**Final Environmental Impact Statement**

**Proposed South Dump Expansion**

**Butte, Montana**

**Montana Department of State Lands**

FIGURE I-4.--Operational changes at the end of year 3 of the mine plan.

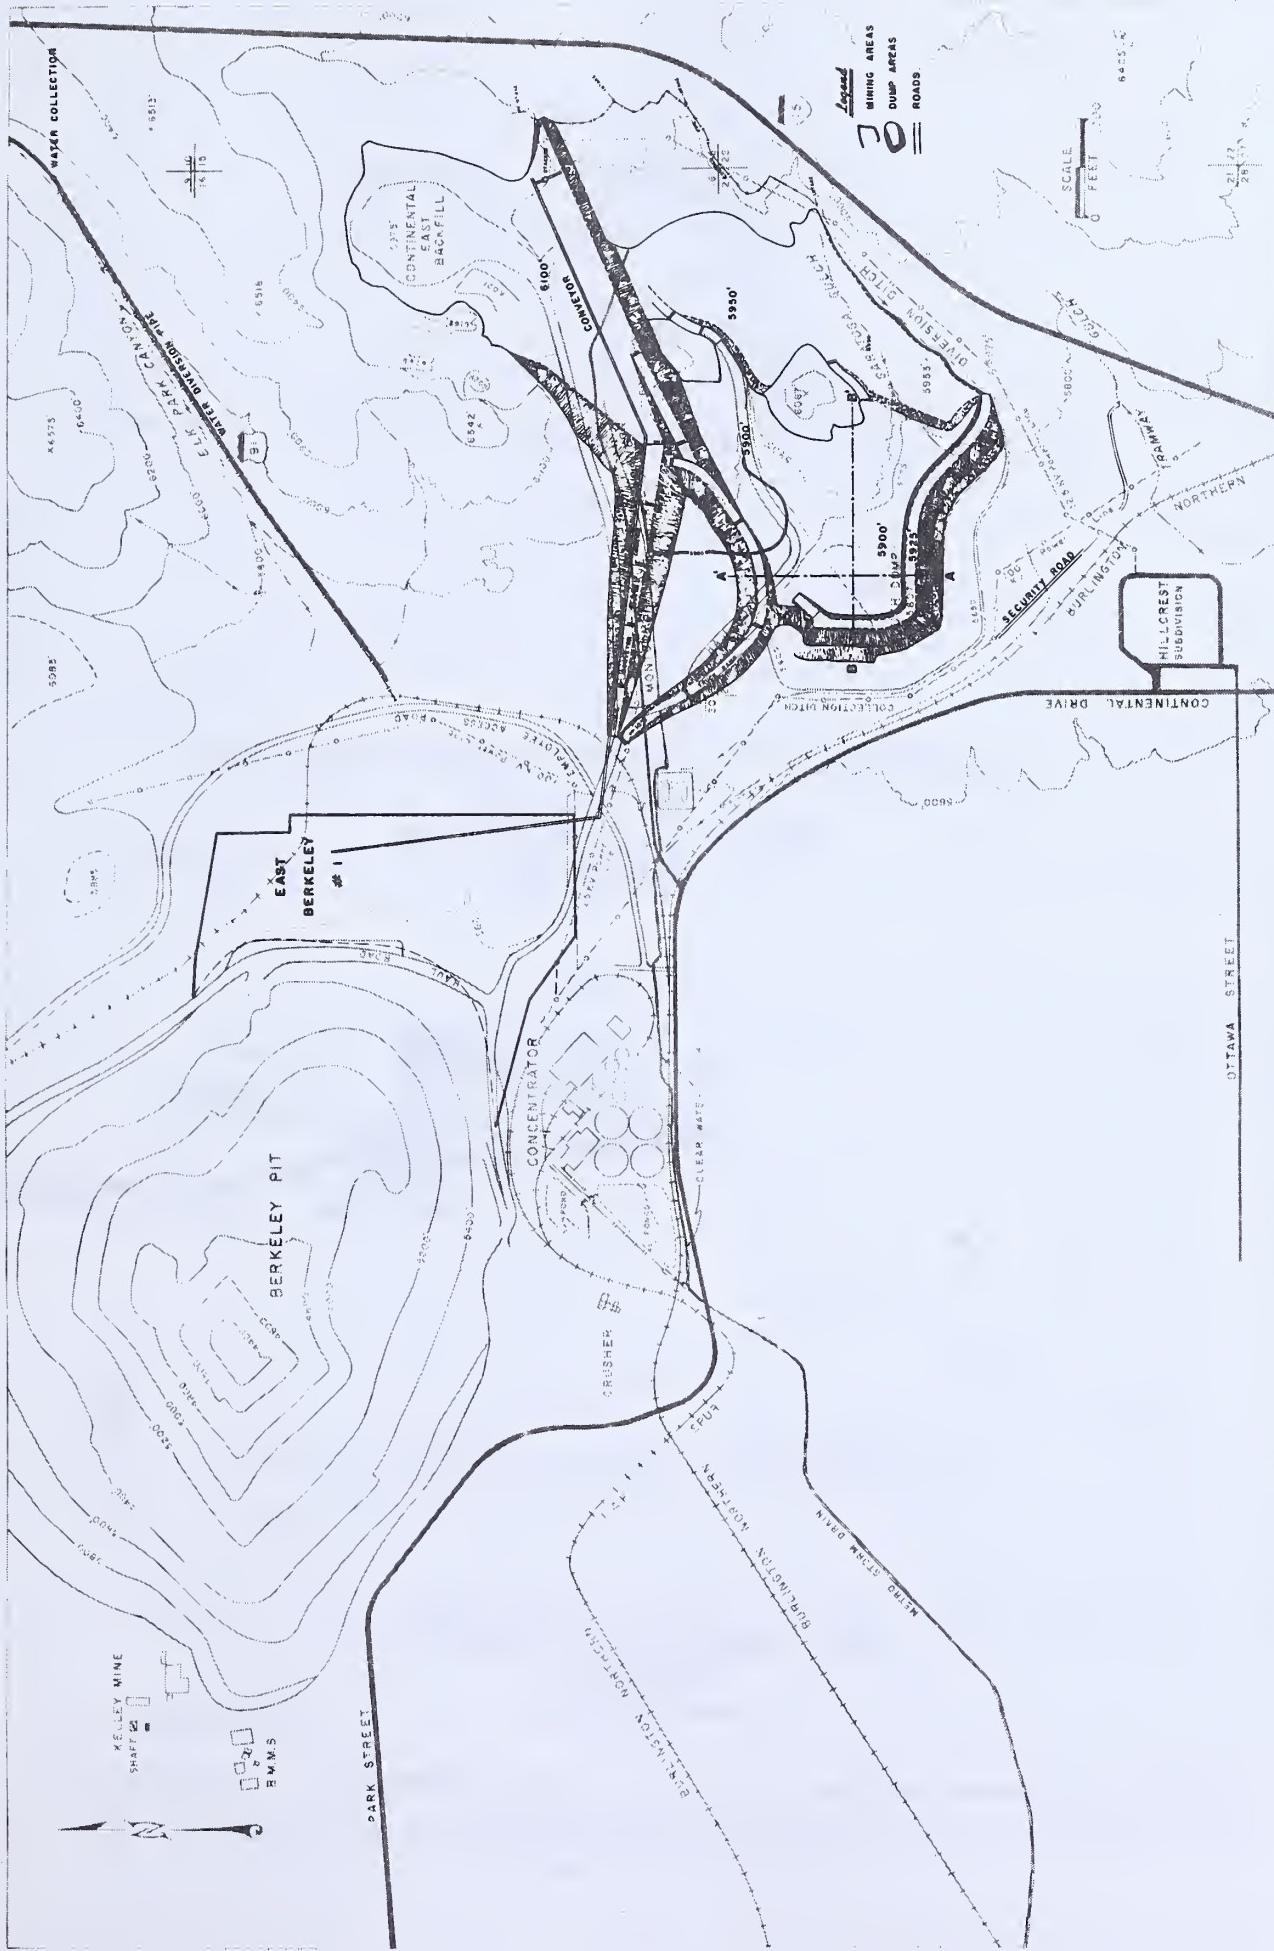
6 Page I-6 d. a. - Include action on long-range (cumulative) implications. Location of new and larger power lines in relation to homeowners property. Should also be shown on Figure I-4.

6 No new and larger powerline is being proposed for the permit area. The existing 12.5kV and 100kW powerlines are shown in figure I-2 and would be slightly relocated. The relocation is not expected to significantly affect the existing environment.

FIGURE I-7.--Operational changes at the end of year 7 of the mine plan.

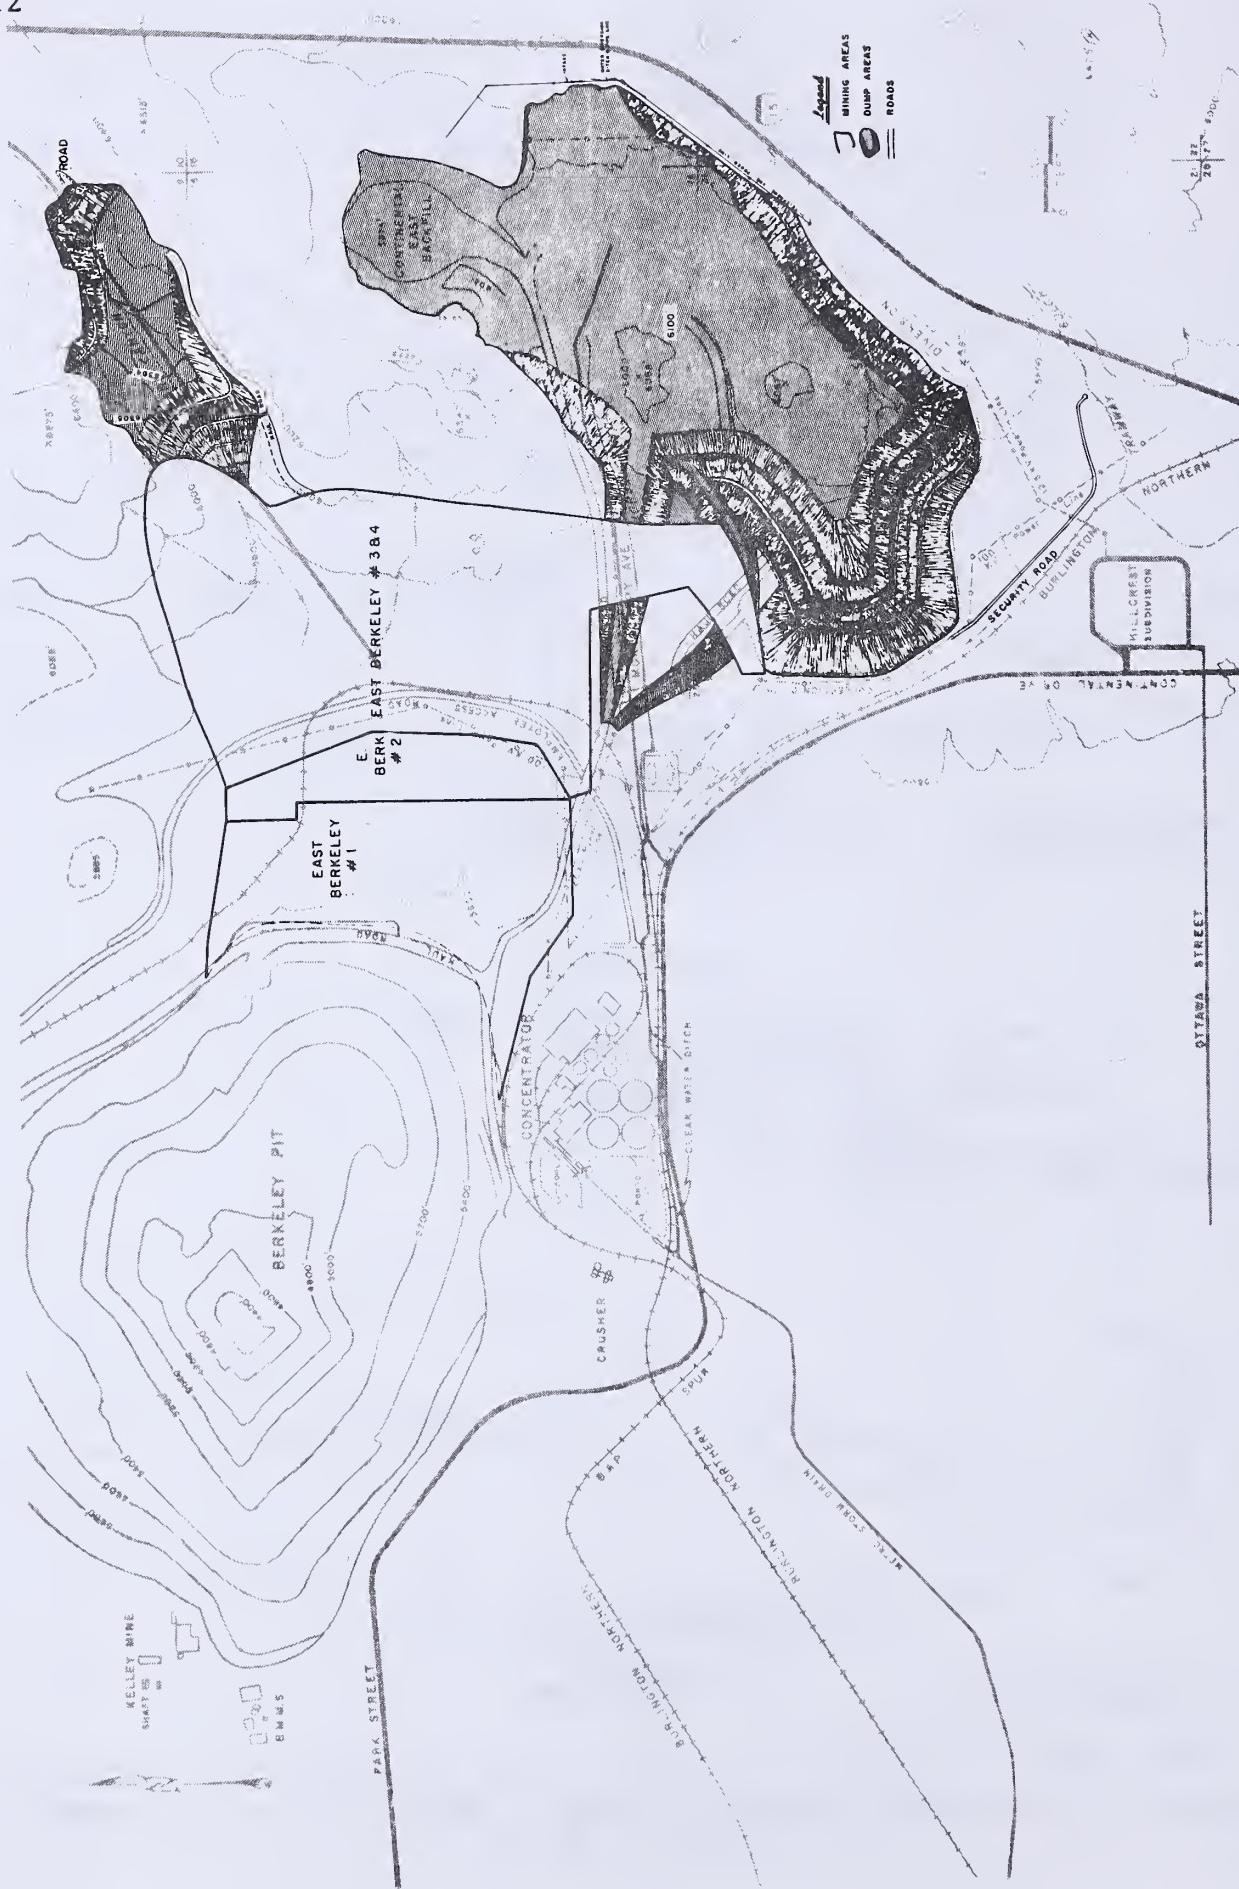
13. On page I-8 filling of the west part of  
the Berkeley Pit is not shown on figure I-7  
as is implied.

13. Only about the eastern one-third of the existing West Berkeley Pit would be backfilled (see fig. I-9). Text has been revised for clarity.

FIGURE II-3.--Ground water elevations and flow directions near the proposed permit area. Source: Hydrometrics, (1980).

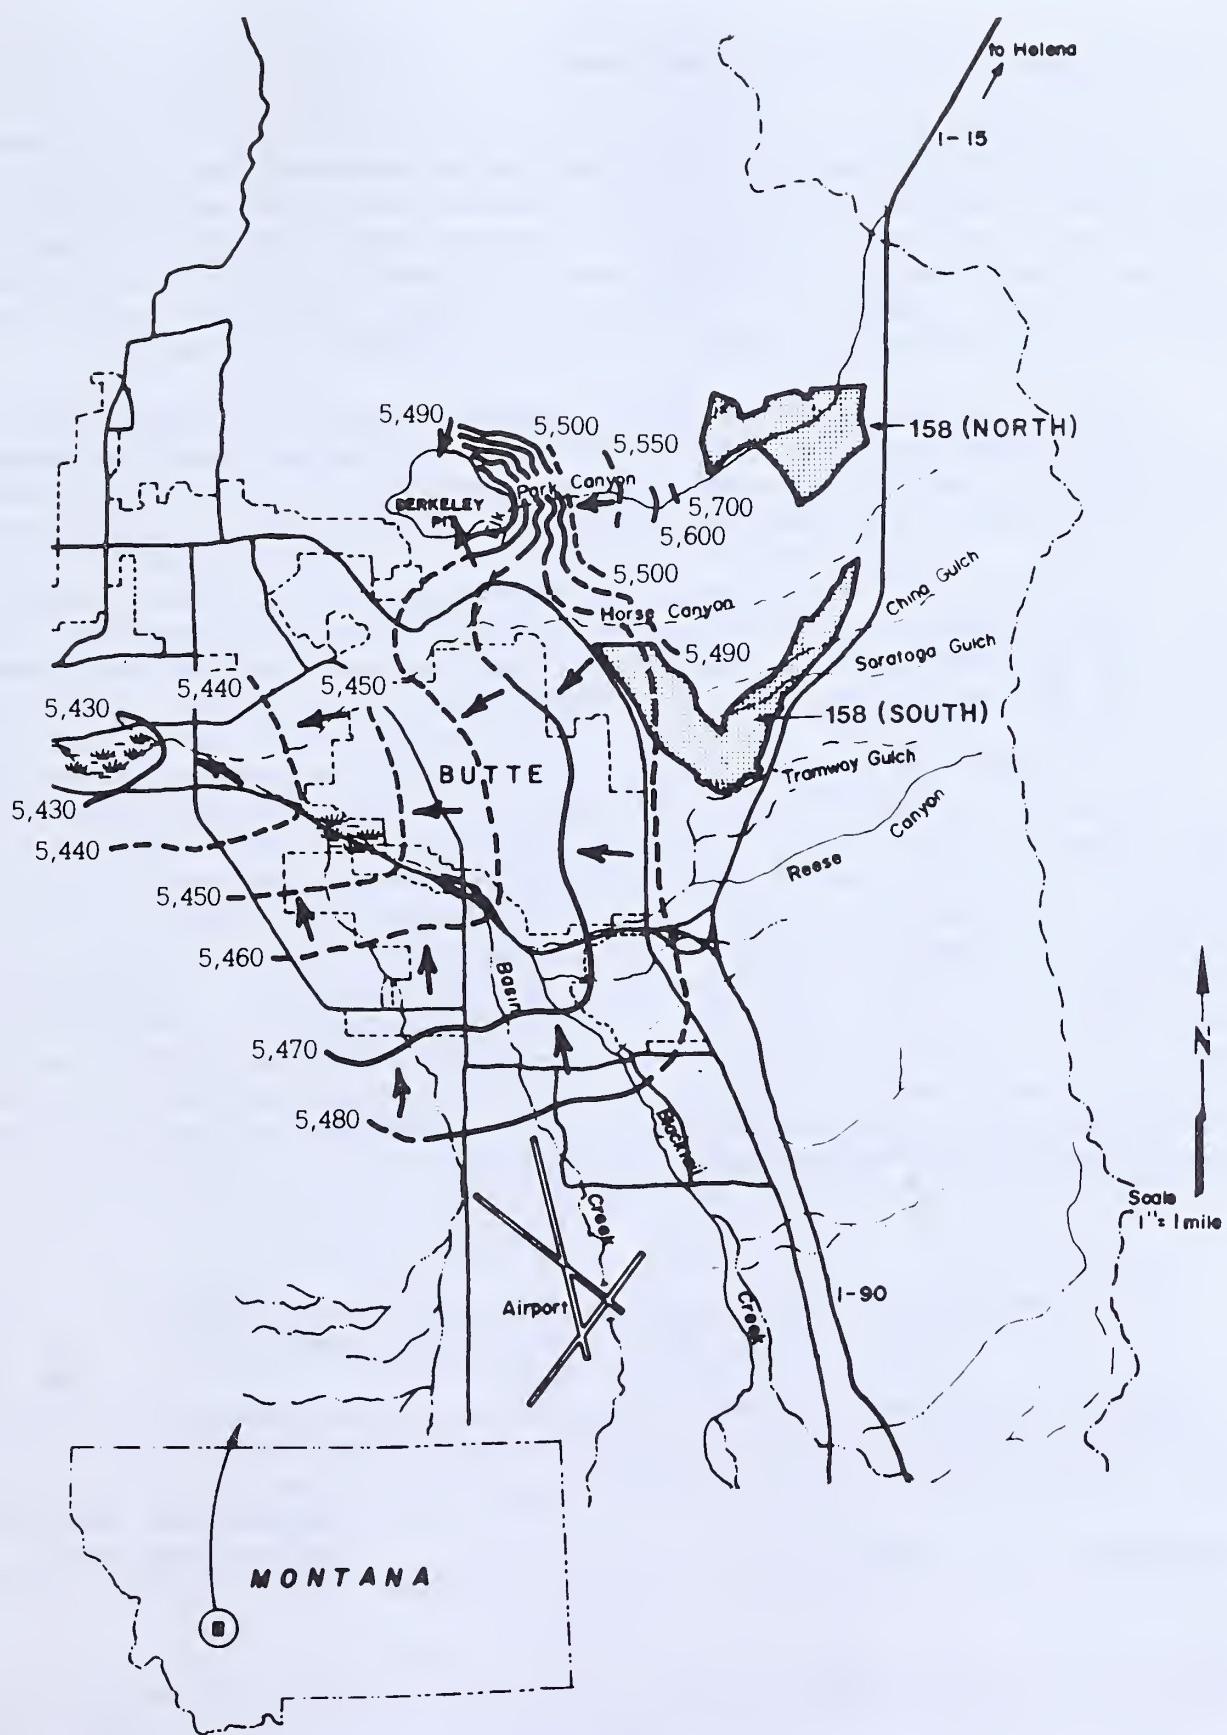
This sentence is not supported by the Figure II-3. The ground water gradient in the vicinity of the South Dump is to the west, not northeast toward the pit. However, with the pit expansion, this will probably be the case.

FIGURE II-9.--Isopleth map of the estimated percentage of total suspended particulate (TSP) due to mining, Summer, 1979.

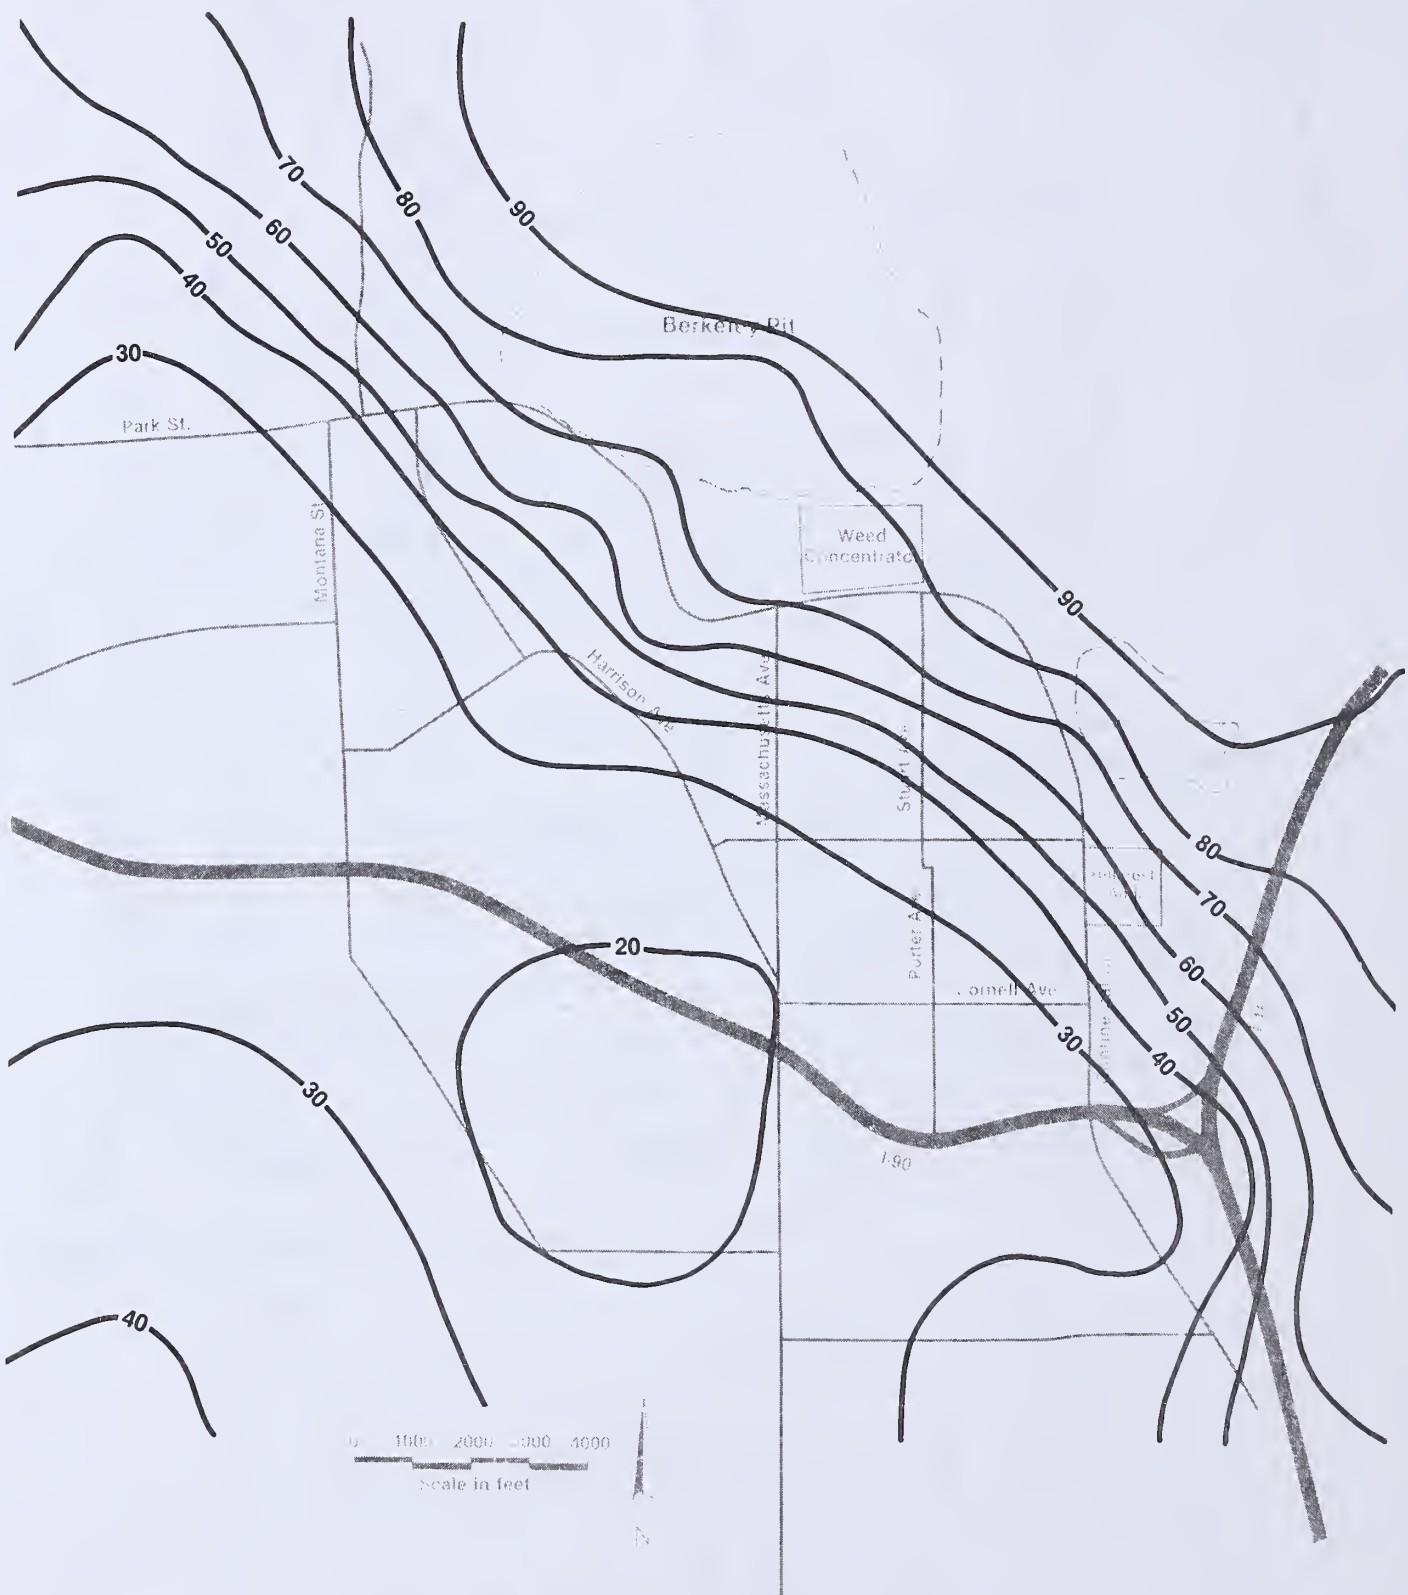
The mining air quality contribution at Hillcrest as shown on page II-29 does not correlate with data in Figure II-9.

Figure II-9 on Page II-32 is in error and is again misleading. Assuming a natural background of 25 ug/m<sup>3</sup> employing data from Table II-9 for the Hillcrest station, the mining contribution for worst case could only be 45% whereas the figure indicates nearly 70%. The Anaconda contribution will be further reduced from 45% when urban effects are considered.

Figure II-32 is not in error. The sentence on page II-29 was in error and has been corrected (see Anaconda comment on EIS ref. p. II-29).

FIGURE III-7.--Approximate configuration of existing south dump and proposed expansion.

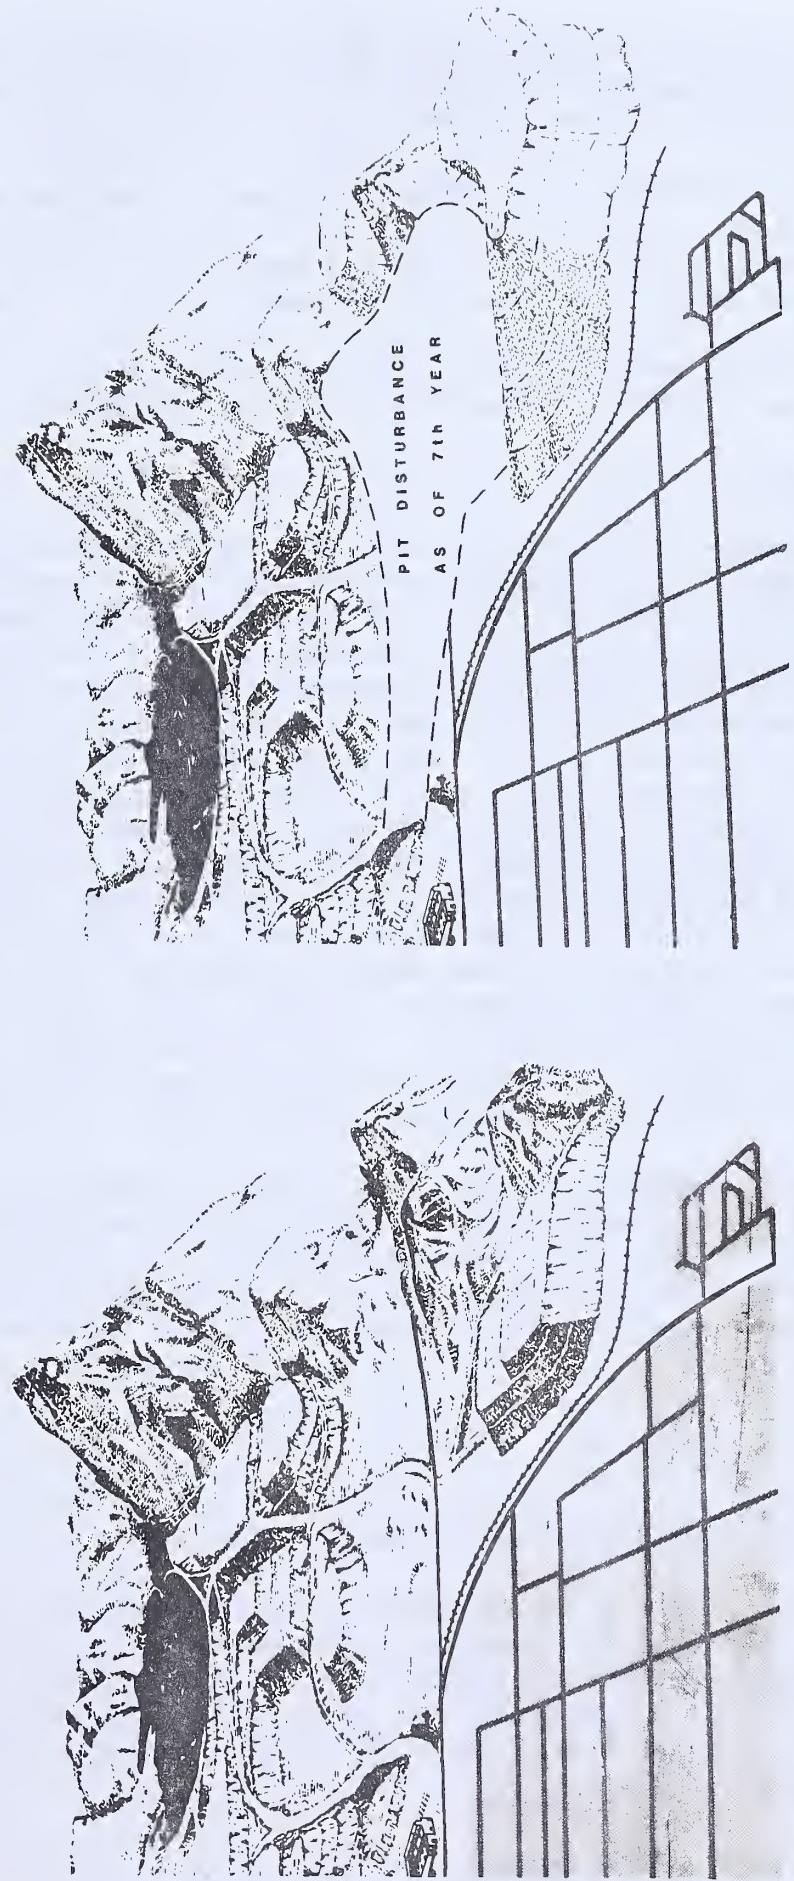
5. Figure III-7 is very interesting in  
that it may be possible for Hillcrest  
residents to see some amount of the  
high peak in the background. Many  
residents thoroughly enjoy that sight  
now. A statement of its visibility would
